January 10, 2023

Consideration of site improvements at the Oregon State Police facility that include constructing building additions, site access and circulation improvements, and enhancing landscape and stormwater management. The 3.59 acre site is located at 4500 Rogue Valley Highway and is identified on the Jackson County Assessor's map as 37S 2W 03BD, Tax Lot 900.

**Applicant:** JE Dunn Construction (Kyle Boehnlein) & DLR Group Architecture (Kent Larson);

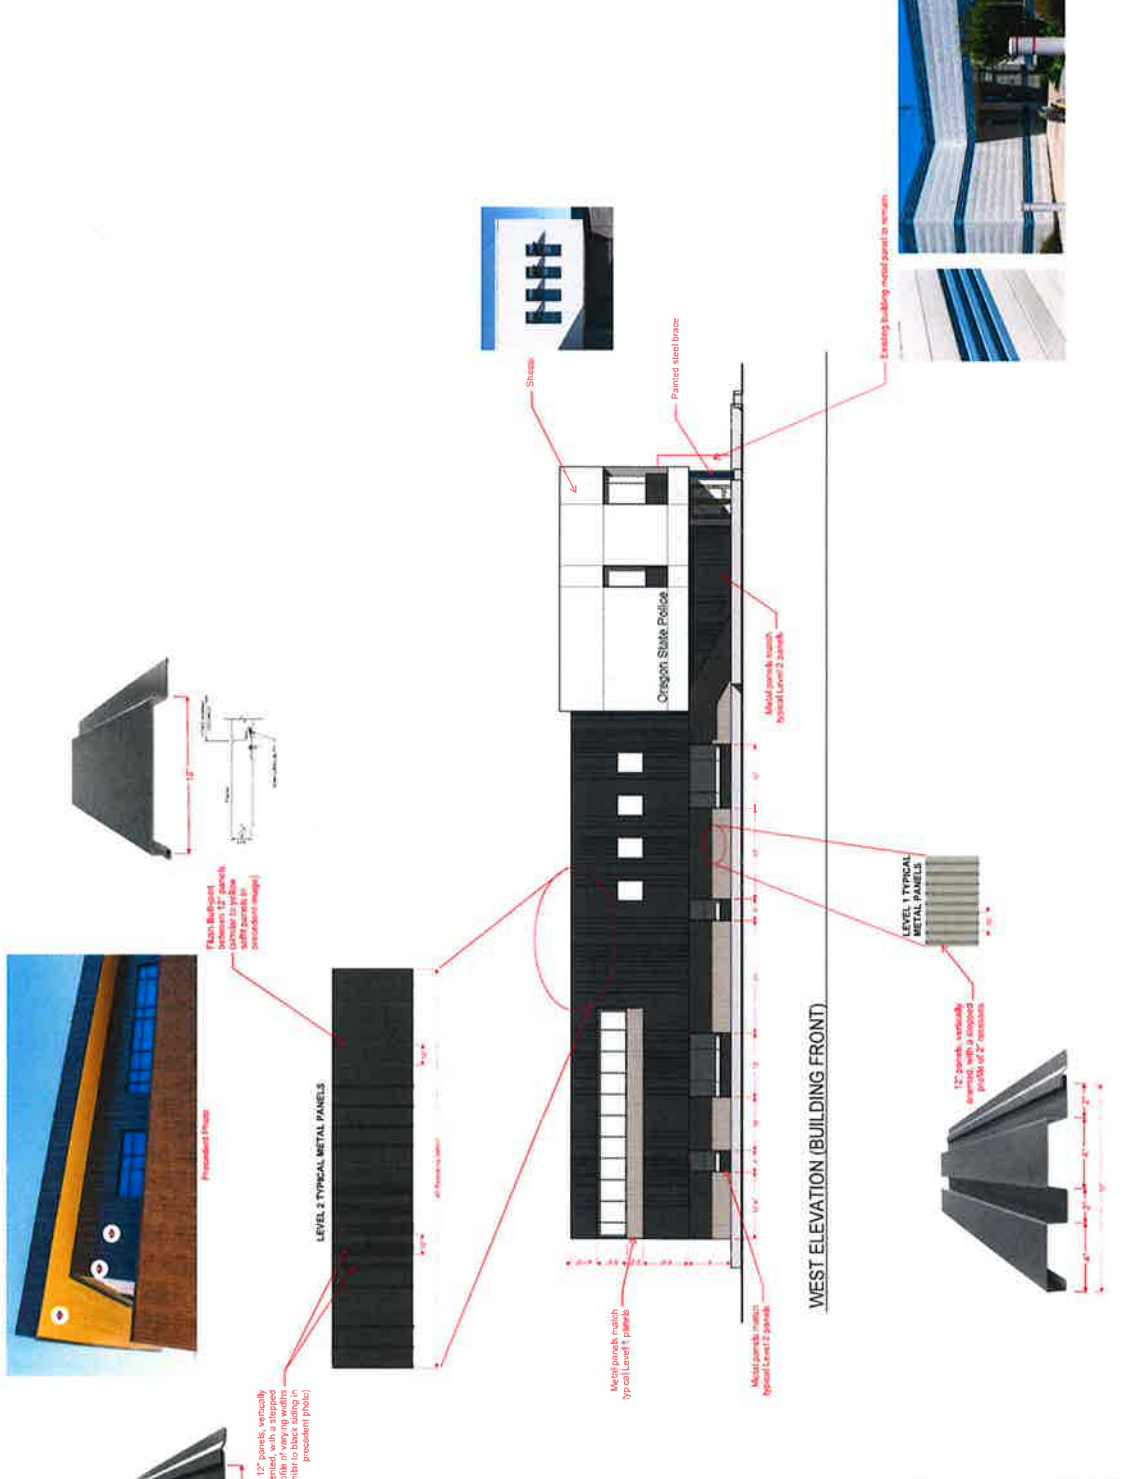
1. **Building Materials.** As required in CPMC 17.67.070(D), the exterior walls of all building facades along pedestrian routes are to be constructed of suitable durable building materials. The Building Elevations (Attachment "A-4") depict exterior materials consisting of metal panels.

**Comment:** Whereas CPMC 17.67.070(D) lists prohibited building materials that include corrugated metal with other nondurable materials, the Applicant's Supplemental Findings (Attachment "C") note that the proposed metal siding is constructed of steel featuring durable finishes, concealed fasteners and multiple articulation profiles. Corrugated metal is typically galvanized roof sheeting with exposed fasteners and a wavy 'S' pattern throughout the installation.

*"Changes of color, texture, or material, either horizontally or vertically, at intervals of not less than twenty feet and not more than one hundred feet."*

RESPONSE: Per attached sheet LU-7 EXTERIOR MATERIALS, there are two typical metal panel applications referred to as "LEVEL 1 TYPICAL" and "LEVEL 2 TYPICAL". These two types differ in color and pattern.

At Level 1, the use LEVEL 2 TYPICAL panels are incorporated below windows to increase vertical articulation. LEVEL 2 TYPICAL panels are also used at the feature exit stair to emphasize the diagonal movement of the horizontal mass above as it descends. Interval lengths are indicated in the dimensions on the front elevation shown on sheet LU-7 attached.

At Level 2, the rhythmic metal panel pattern repeats at 20' horizontal intervals and stops at the cantilevered stucco box. LEVEL 2 TYPICAL panels are used below the ribbon windows to add vertical height and align with adjacent windows.
